Access Compliance Report

Public Rights-of-Way

Intersection ID: 13418	Main Street: SOUTHWOOD_AV	Cross Street: WESTWOOD_AV	Location:	N
ADA ID: B7D43AC6282B	Ramp Type: PerpDiag	Initial Pass/Fail: Fail	Overall Compliance: No	Severity Score: 12.5
Codes/Mitigation Info/Possible Solution		Field Measurements/Component Compliance

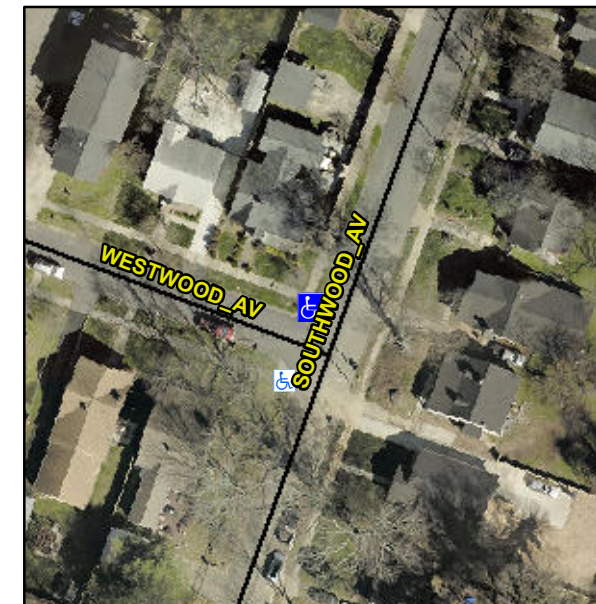
Remove & Replace Curb Ramp With Two New Directional Ramps or Equivalent.

R304.5.3

Compliance	Description	Data	Compliance	Description	Data
N/A	Ramp Length (in)	99.0	Yes	Ramp Slope (%)	7.1
Yes	Ramp Width (in)	72.0	No	Ramp XSlope (%)	5.6
N/A	Flare Type LT	N/A	N/A	Flare Type RT	N/A
N/A	Flare Slope LT (%)	N/A	N/A	Flare Slope RT (%)	N/A
N/A	Flare Traversable LT?	N/A	N/A	Flare Traversable RT?	N/A
N/A	Landing Length (in)	N/A	N/A	DWS Provided?	N/A
N/A	Landing Width (in)	N/A	N/A	DWS Contrast?	N/A
N/A	Landing Slope (%)	N/A	N/A	DWS Length (in)	N/A
N/A	Landing X Slope (%)	N/A	N/A	DWS Full Width?	N/A
N/A	Landing Curb? (Y/N)	N/A	N/A	DWS Offset (in)	N/A
N/A	Shared Landing?	N/A			
N/A	Gutter Ponding?	N/A	N/A	Gutter Slope (%)	N/A
N/A	Gutter Lip Ht (in)	N/A	N/A	Gutter X Slope (%)	N/A
N/A	Painted X Walk1?	No	N/A	Painted X Walk2?	No
	X Walk 1 Direction	To SW		X Walk 2 Direction	To SE
N/A	X Walk 1 Width (in)	N/A	N/A	X Walk 2 Width (in)	N/A
	X Walk 1 Slope (%)	0.9		X Walk 2 Slope (%)	8.3
	X Walk 1 X Slope (%)	4.9		X Walk 2 X Slope (%)	2.3
